RS-13-178

Peach Bottom Atomic Power Station, Units 2 and 3
Renewed Facility Operating License Nos. DPR-44 and DPR-56
NRC Docket Nos. 50-277 and 50-278

Subject: Response to Request for Additional Information - Overall Integrated Plan in Response to Commission Order Modifying License Requirements for Reliable Spent Fuel Pool Instrumentation (Order No. EA-12-051)

Response to Request for Additional Information

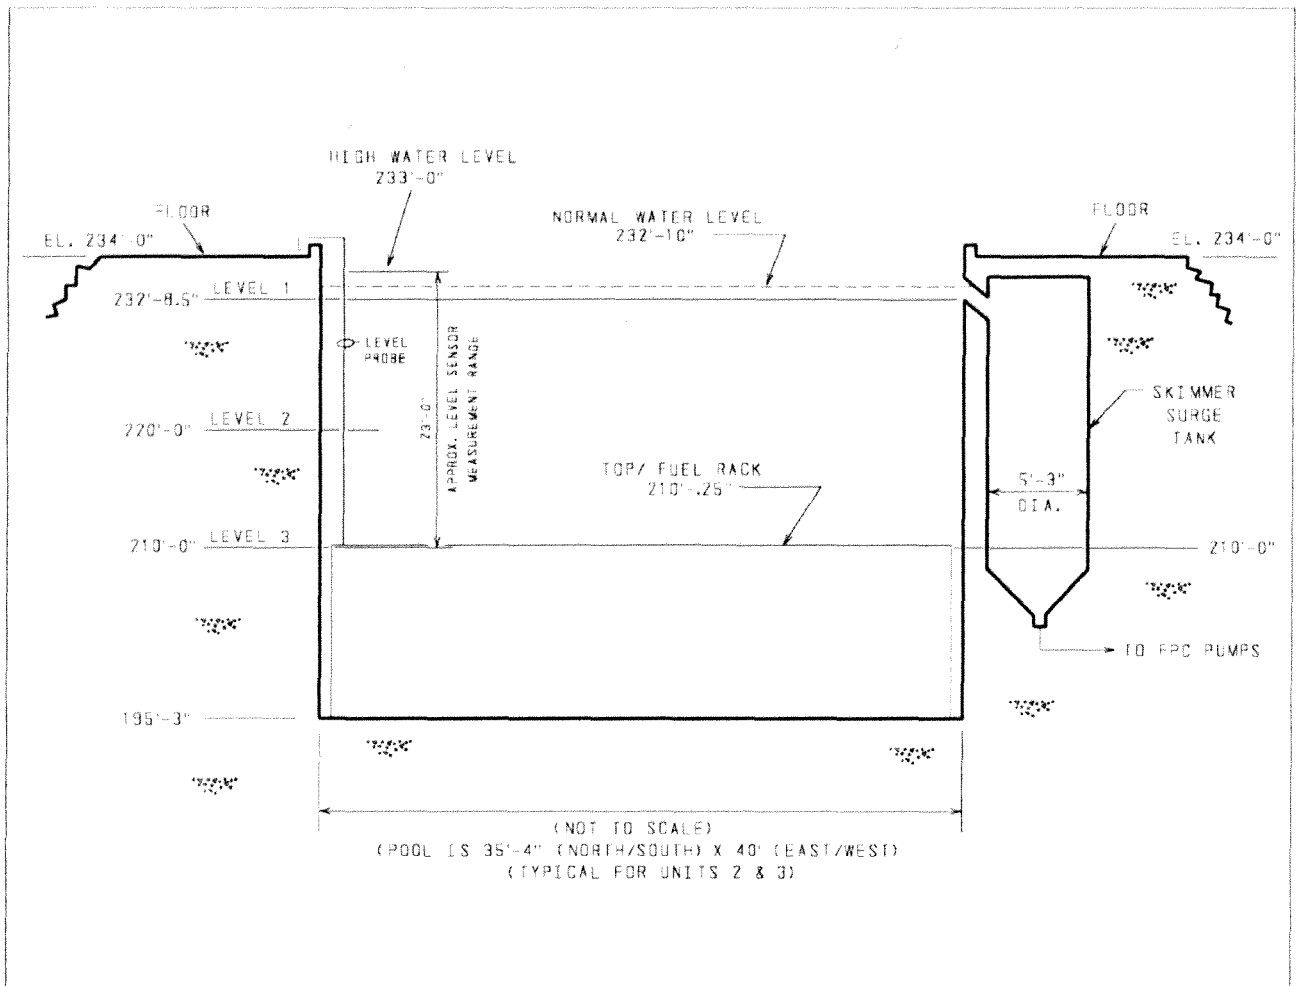
- a) For level 1, specify how the identified location represents the HIGHER of the two points described in the NEI 12-02 guidance for this level.
- b) A clearly labeled sketch depicting the elevation view of the proposed typical mounting arrangement for the portions of instrument channel consisting of permanent measurement channel equipment (e.g., fixed level sensors and/or stilling wells, and mounting brackets). Indicate on this sketch the datum values representing Level 1, Level 2, and Level 3, as well as the top of the fuel racks. Indicate on this sketch the portion of the level sensor measurement range that is sensitive to measurement of the fuel pool level, with respect to the Level 1, Level 2, and Level 3 datum points.

- a) The Spent Fuel Pools at Peach Bottom Units 2 and 3 have skimmers and scuppers. The top of the weir is normally set at elevation 232'- 8.5" to maintain a Spent Fuel Pool water level of 232'-10" when the Fuel Pool Cooling system is in service. The water in the fuel pool flows over the weir and into the skimmer surge tanks from which the Fuel Pool Cooling Pumps draw suction. Fuel Pool Skimmer Surge Tank Level switches LS-2(3)696 will trip the Fuel Pool Cooling Pumps if the Skimmer Surge Tank level falls to elevation 213'-0". Therefore the 232'-10" elevation based on the elevation of the fuel pool weir is the higher of the two points noted in NEI 12-02, Section 2.3.1.
- b) Please reference the following sketch. Level probe mounting details in the Spent Fuel Pool area will be provided in accordance with the response to RAI-3.
